Project: Stiltsville Fish Bar
1787 Purdy Ave.
Miami Beach, FL 33139

Please find responses in reference to Comments BDRB20-0548

Final/ Formal Submittal
Letter of Intent for Design Review Board
Application DRB20-0548 (fka 23220)
Stiltsville Fish Bar, 1787 Purdy Avenue
Miami Beach, FL 33139

ROOF DECK ADDITION

1 Roof Top & Exterior Lighting
1/8" = 1'-0"

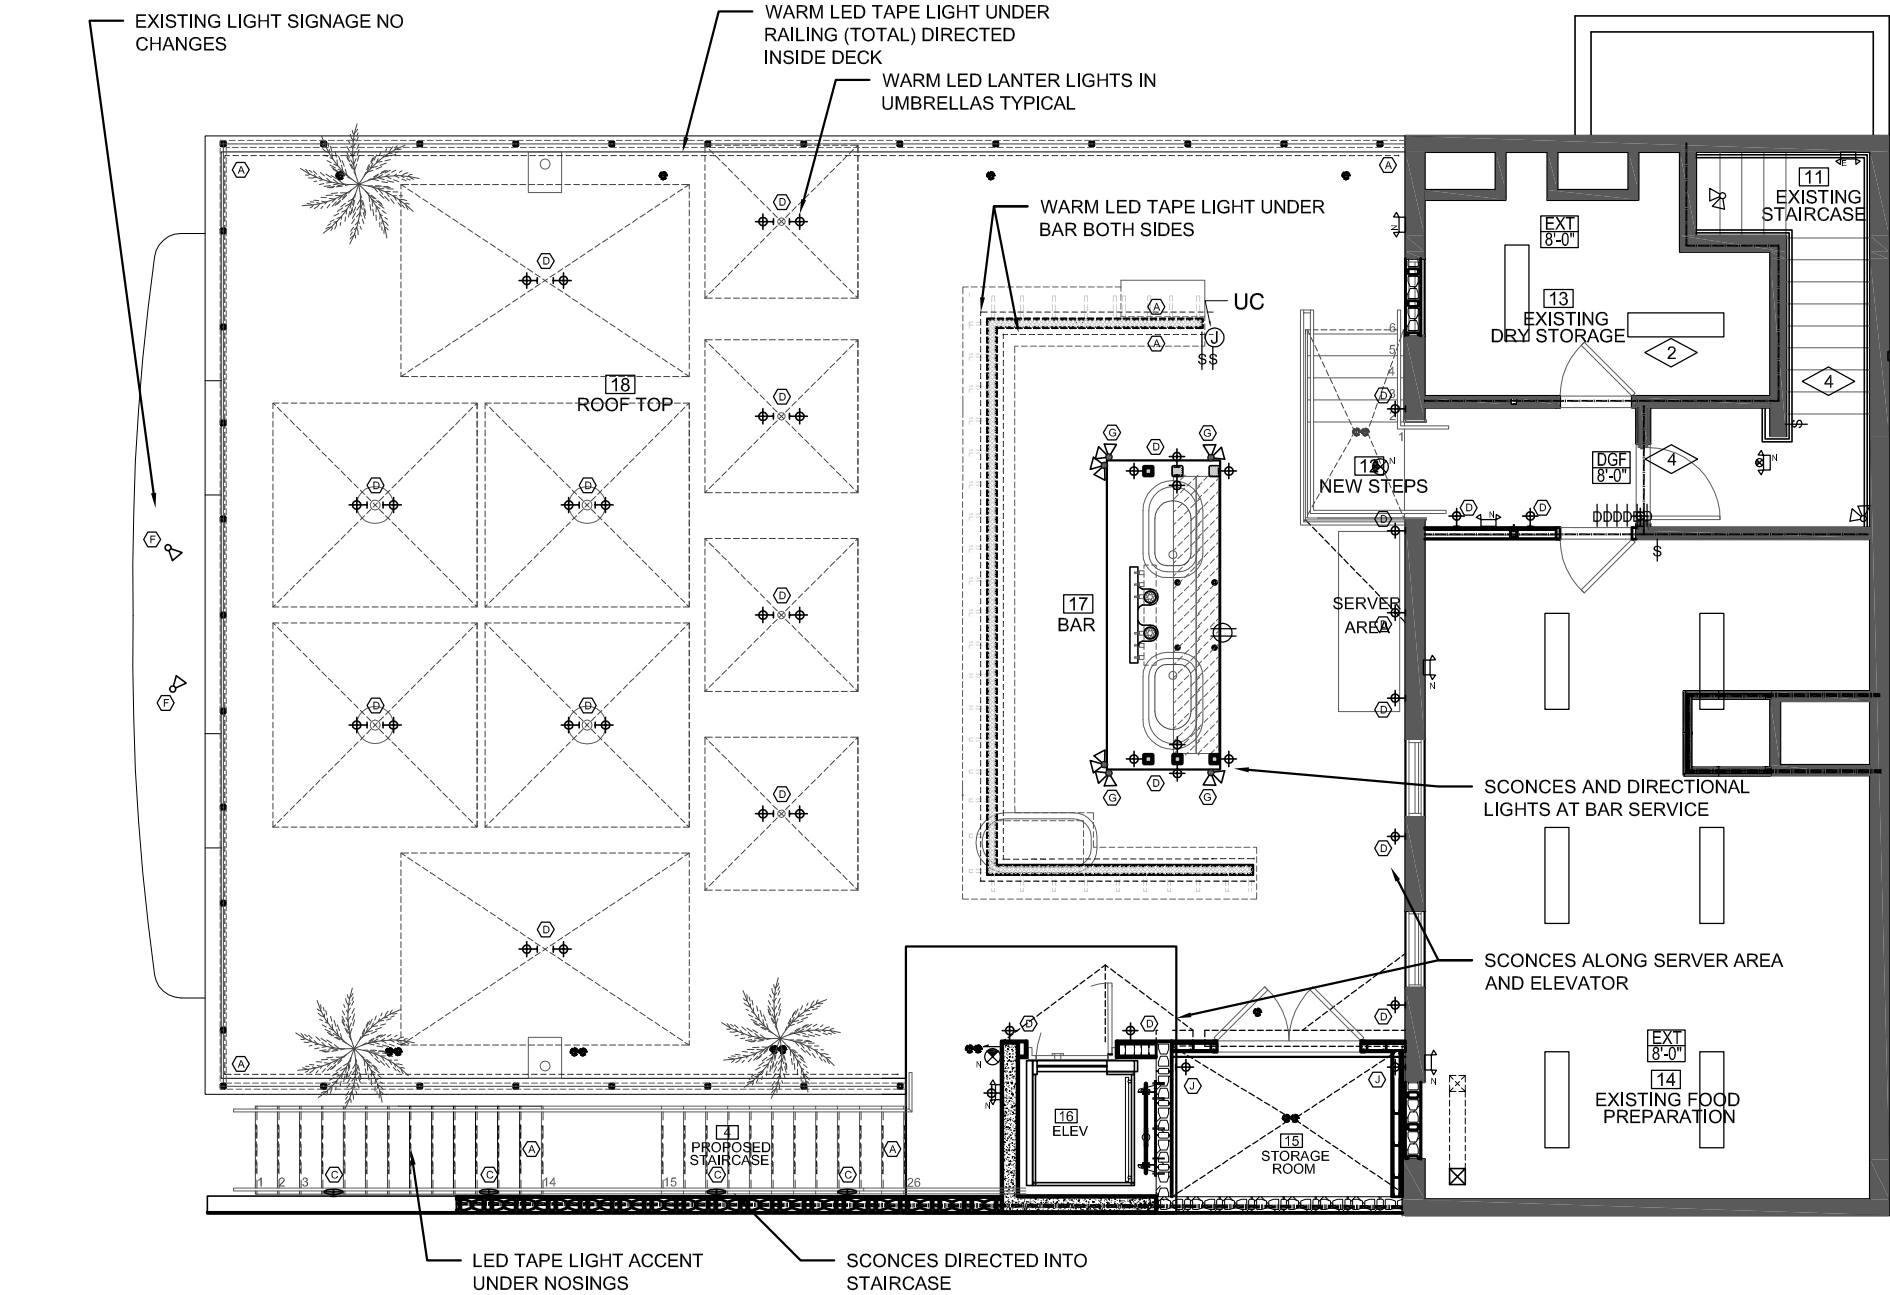
- k. Rendering Updated to reflect staircase direction.
 - l. Lighting Plan Updated
